SUBJECT: ATLAS TER INPUT - SECTIONS 2, 3, 4, AND 6

In accordance with Mike Fliegel's request, we have completed our review of the Reclamation Plan (RP) for the Atlas uranium mill in Moab, Utah. Based on our review, we conclude that additional information regarding rock gradations, landslides, radon barrier design, geotechnical engineering, and seismic design will be needed before the RP can be approved.

Figure 2. Seismicity cross sections through the Canyonlands region keyed to Figure 5.

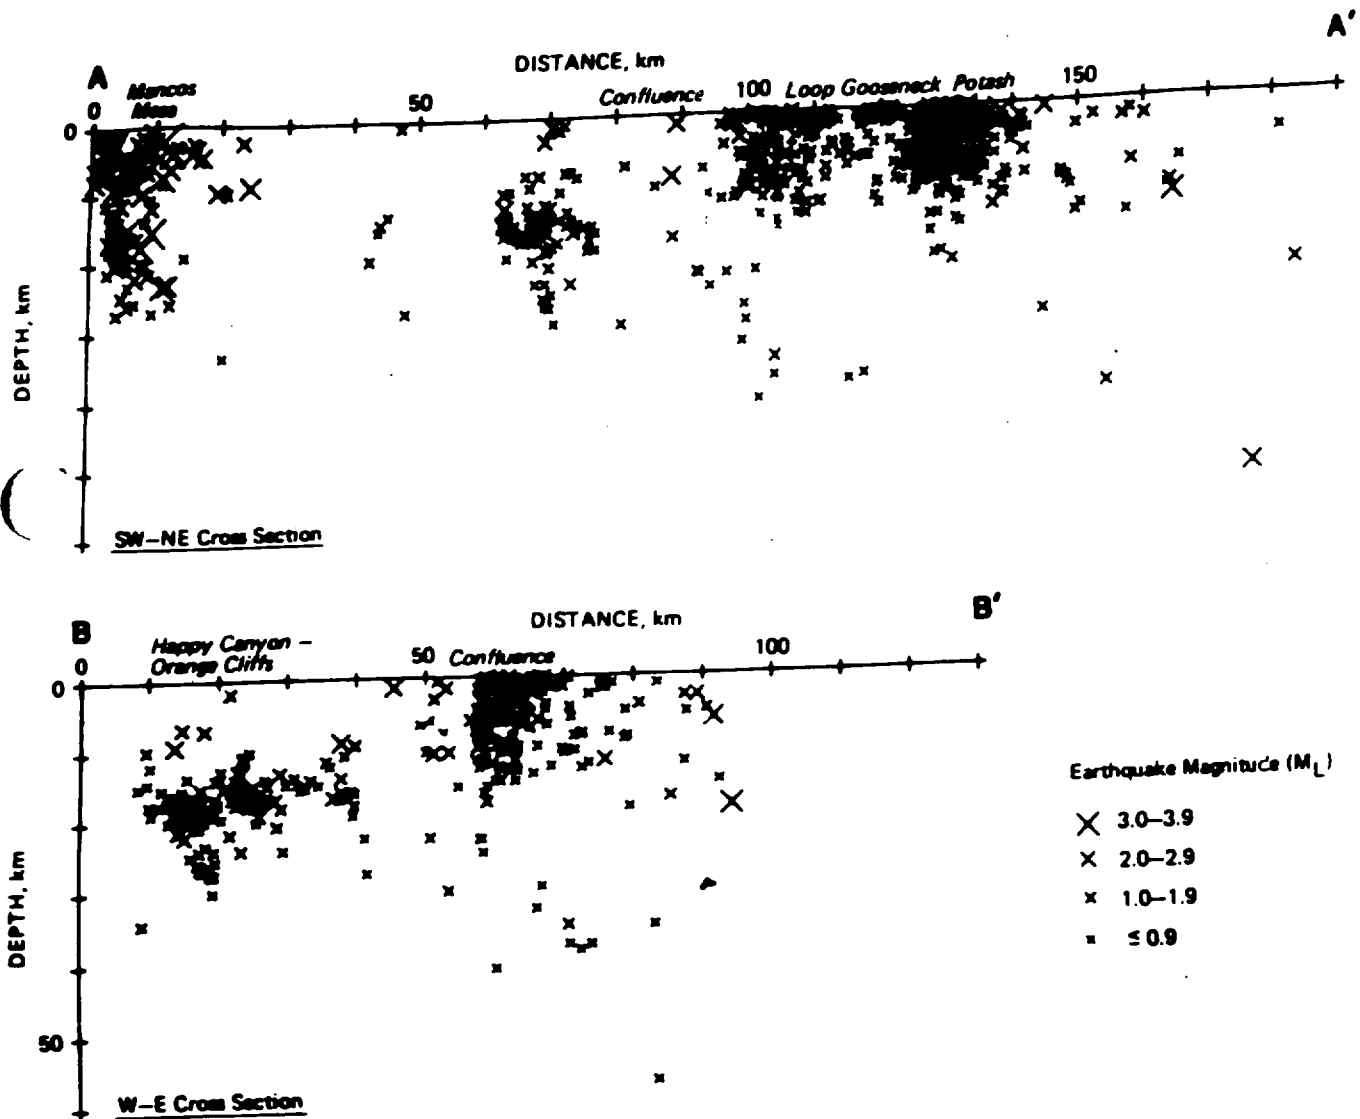
The other potentially significant seismic source of earthquakes is the northeast-trending feature along the Colorado River north of the confluence with the Green River. Wong and Humphrey (1989) located several seismic events in this area along the Colorado River. The focal depths of these earthquakes range from shallow up to about approximately 50 km (Figure 2-1). Considering that these earthquakes may be associated with the basement faulting, the staff estimated (Figure 2-2) that the length of the basement fault could be approximately 50 km. A reasonable estimate of a seismic event from this fault would consider only one-half of the fault length to rupture in any one event. Based on the relation developed by Wells and Coppersmith [1994, Figure 14, (a), which is the most recent work on this subject found by the staff], the staff estimated the magnitude resulting from a 25 km subsurface rupture on this fault to be 6.5. If the total length of the fault, 50 km, were to rupture, the magnitude would be approximately 7.0. This earthquake represents the largest and the closest event to the site.

RECLAIMED IMPOUNDMENT SOIL COVER PROFILES

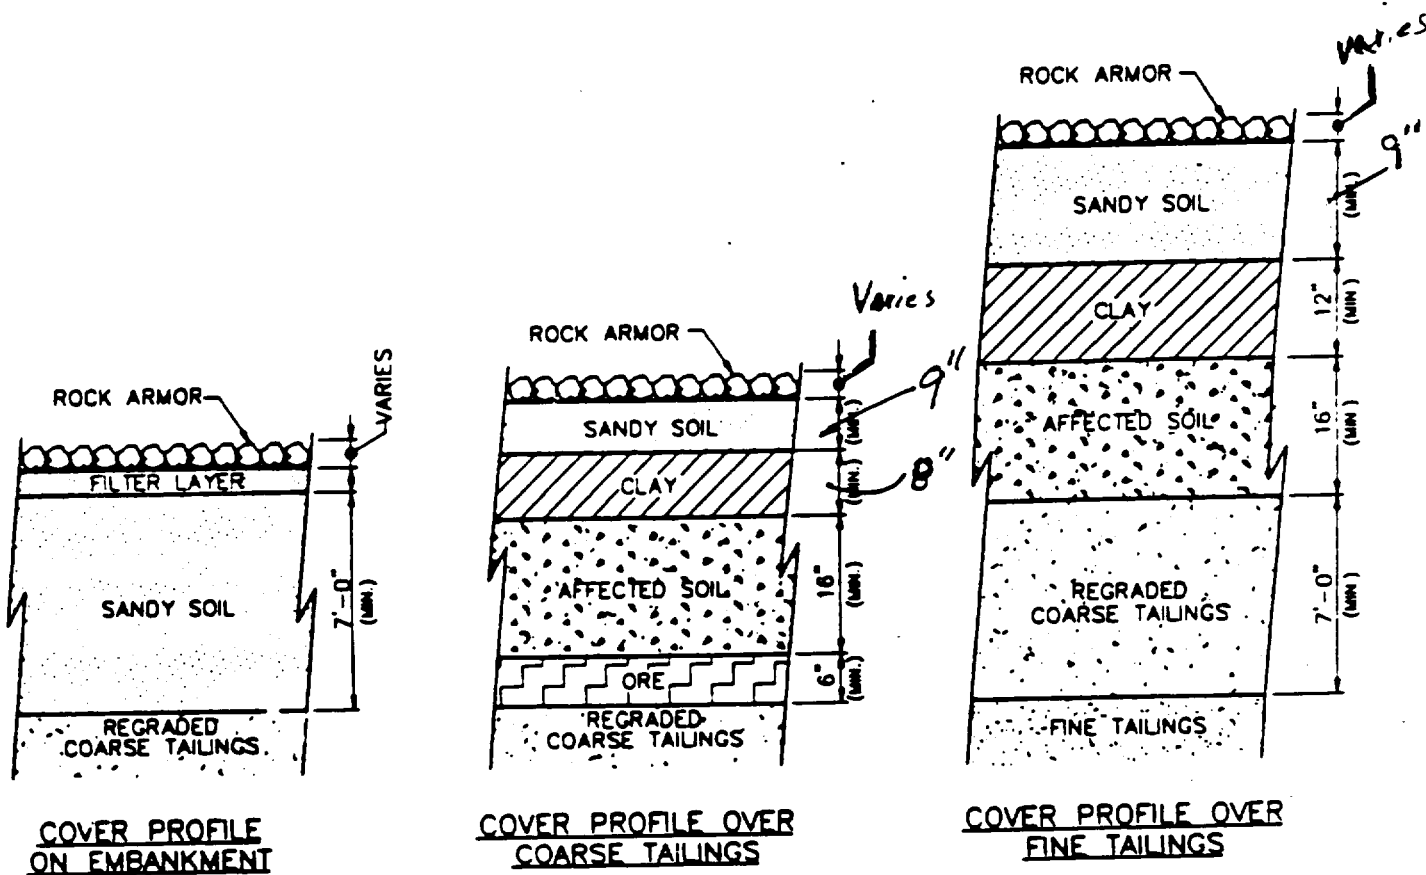
In response to NRC staff comments, Atlas proposed a revised radon barrier design for the top slope in March 1995 (see Figure 6-1), based on a revised radon model using more conservative parameter values. The radon barrier minimum thickness (clay plus sandy layers) has been increased from 12 inches to 17 inches over the coarse tailings area, and to 21 inches over the fine tailings area. The clay layer will be a minimum of 8 inches thick over the coarse tailings area and 12 inches thick over the fine tailings area. The clean soil layer minimum thickness has been increased from 6 inches to 9 inches over the entire top slope. Because the side slopes do not contain fine tailings or the clay layer, Atlas did not change the model for that area. The Atlas modeling results indicate that the long-term radon flux should be 19.1, 19.8, and 18.5 pCi/m<sup>2</sup>s for the side slopes, fine tailings, and coarse tailings areas, respectively.
